**AGENDA
VILLAGE OF GLENCOE
ZONING BOARD OF APPEALS
REGULAR MEETING**

3. CONSIDERATION OF TWO VARIATIONS FROM THE ZONING CODE TO ALLOW AIR CONDITIONING UNITS TO ENCROACH INTO THE SIDE YARD SETBACK AND TO BE LOCATED CLOSER THAN ONE-HALF LOT DEPTH FROM THE STREET AT A NEW SINGLE-FAMILY RESIDENCE AT 275 GREENWOOD AVENUE.

Zoning Board of Appeals Memorandum

SUBJECT: Consideration of variations to allow two air conditioning units to encroach into the side setback and to be closer than one-half lot depth from the street at 275 Greenwood Avenue

1	63021		
NO.	DATE		
275 GREENWOOD AVE. GLENCOE, IL			
		DATE	
		5/26/21	
VICTOR CARDONA, P.E. 3529 OAKHILL LN. LONG GROVE, IL 847-323-2686 cel AVILAONE@HOTMAIL.COM			
AS BUILT

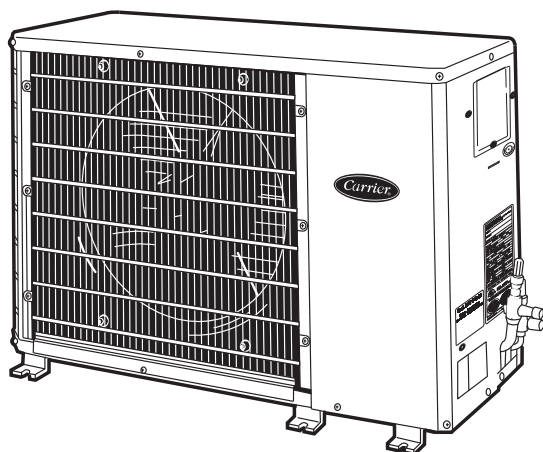
The air conditioning units have been installed in the required setback at a new home on an undersized corner lot. The approved building permit showed the units in the rear yard near the garage in a location that would not require a variation. Per the applicants, if the units were placed near the garage, it would limit the ability to use the back patio. While the applicants have stated that the units are not highly visible from the street and will be screened with landscaping, site visits have shown that the units are

This corner lot is undersized in terms of lot width and lot area which present a unique physical condition. The lot width is just under 44 feet and the minimum lot width for the RC district is 60 feet. The lot area is approximately 6,129 square feet and the minimum lot area for the RC district is 10,000 square feet. The front of the home faces Greenwood Avenue, while what is technically the front yard is along Oakdale Avenue, which triggers the second variation request for an accessory structure to be less than 50% of the lot depth from the street.

The 50% lot depth requirement for accessory structures is intended to prevent accessory structures from being highly visible from the public right-of-way. As currently installed, one of the units is highly visible from the sidewalk, but because it is located further from the street than the house, it could likely be screened with vegetation. The same unit is also highly visible from the neighboring property to the east. If the ZBA chose to include a condition of approval requiring adequate screening, it is likely that the variations would not result in a development out of harmony with the purposes of the code.

The proposed variations could be detrimental to the enjoyment of the property immediately to the east if adequate screening of the units is not in place. The ZBA may consider conditions of approval requiring this screening to be installed.
